INTERIM DRAWING CHANGE NOTICE (IDCN)  
 SUPPLEMENTAL PAGE  
**AFTER**

QUAL. C. REC. II  
 UNIT I  
 SAN ONOPE RUPREAN GENERATING STATION  
 AREA GAS CONDUIT & TRAY PLAN  
 ELEVATION 50' TO 70'-0"  
 SOUTHERN CALIFORNIA Edison COMPANY  
 1000 J. STREET  
 SAN DIEGO, CALIF. 92161

DCR24304.0J REV 0 SHEET 140 OF 199

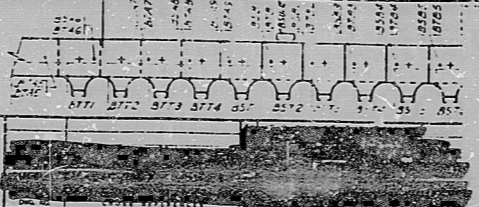
XSAT - EL 65'-10"	SDAI - EL 62'-5"	SDAR - W	XSOU - EL 62'-5"
XXAI - 64'-6"	SDAI - W	SDAZ - W	XYKI - W
XXAI - 65'-2"	SDAI - W	SDAZ - W	XYKI - W
	SDAI - W	SDAZ - W	XYKI - W
	SDAI - W	SDAZ - W	XYKI - W
